CAMPAIGN 5623 - Service Campaign

**Model: Fiat Ducato with 2.3 JTD 130 HP and 150 HP Euro 5 engine
- engine compartment junction unit**

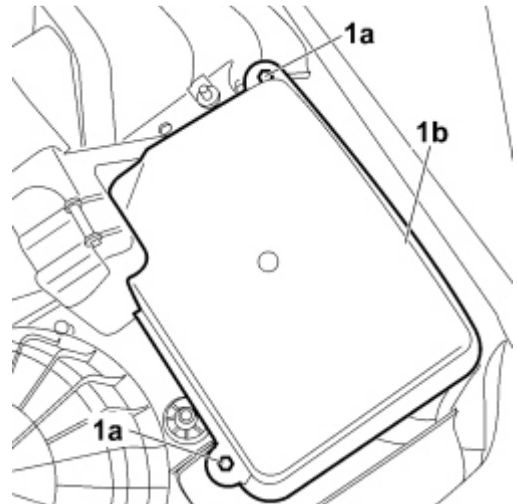
- Turn the ignition key to the Stop position.
- Open the bonnet.
- Disconnect the negative battery terminal.
- Undo the fixing nuts (1a) and remove the junction unit cover (1b).

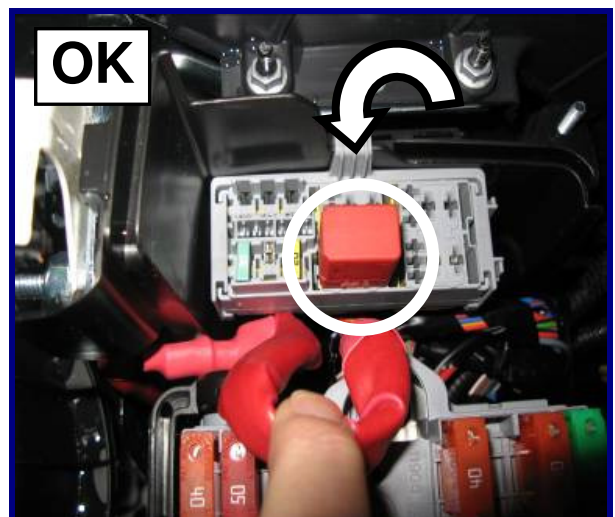
- Remove the relay switch on the junction unit, from position T27 (wrong).

- Place the relay switch on the junction unit in position T22 (correct).
